SUBJECT: ISSUANCE OF AMENDMENT FOR CALVERT CLIFFS NUCLEAR POWER PLANT,
UNIT 1 (TAC NO. 77292)

AMENDMENT TO FACILITY OPERATING LICENSE

Amendment No. 146
License No. DPR-53

SAFETY EVALUATION BY THE OFFICE OF NUCLEAR REACTOR REGULATION
RELATED TO AMENDMENT NO. 146 TO FACILITY OPERATING LICENSE NO. DPR-53
BALTIMORE GAS AND ELECTRIC COMPANY
CALVERT CLIFFS NUCLEAR POWER PLANT, UNIT 1
DOCKET NO. 50-317

FIGURE 3.4-2a
CALVERT CLIFFS UNIT 1 HEATUP CURVE, 12 Y
REACTOR COOLANT SYSTEM PRESSURE TEMPERATURE LIMITS

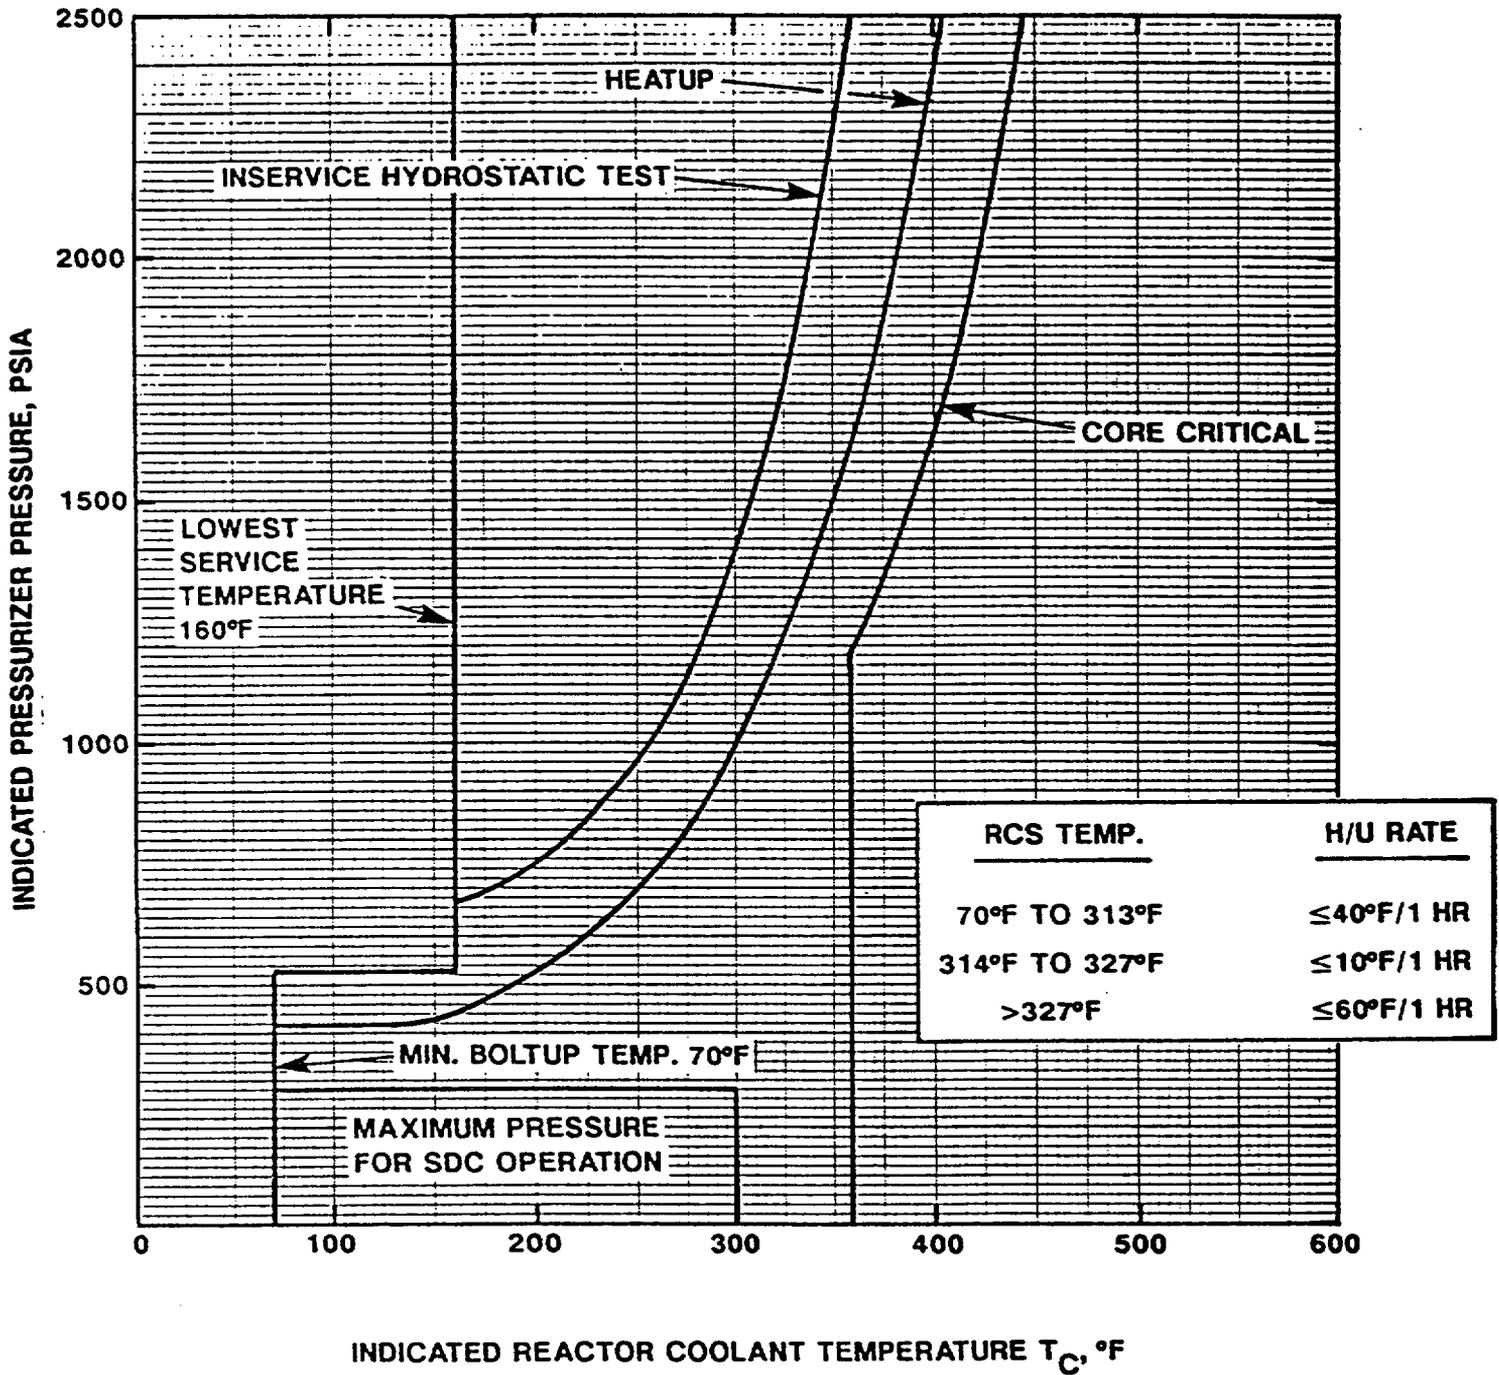
For this review the staff used the same reference temperature from the previous review and SRP 5.3.2 to verify the proposed P/T limits. The licensee changed the heatup rate from 60°F/hr to 40°F/hr for the reactor coolant temperature that ranges from 70°F to 313°F. The cooldown rate was changed from 20°F/hr to 10°F/hr when the reactor coolant temperature is less than 170°F. The proposed P/T limits with these changes are within the allowable limits of SRP 5.3.2. Hence, the proposed P/T limits, TS 3.4.9, TS Figures 3.4-2a, and 3.4-2b are acceptable and may be incorporated into the Calvert Cliffs, Unit 1, TS.

The licensee provided its updated P/T curves in proposed TS Figure 3.4-2a (for heatup) and Figure 3.4-2b (for cooldown). The necessary adjustments of LTOP controls are as follows:
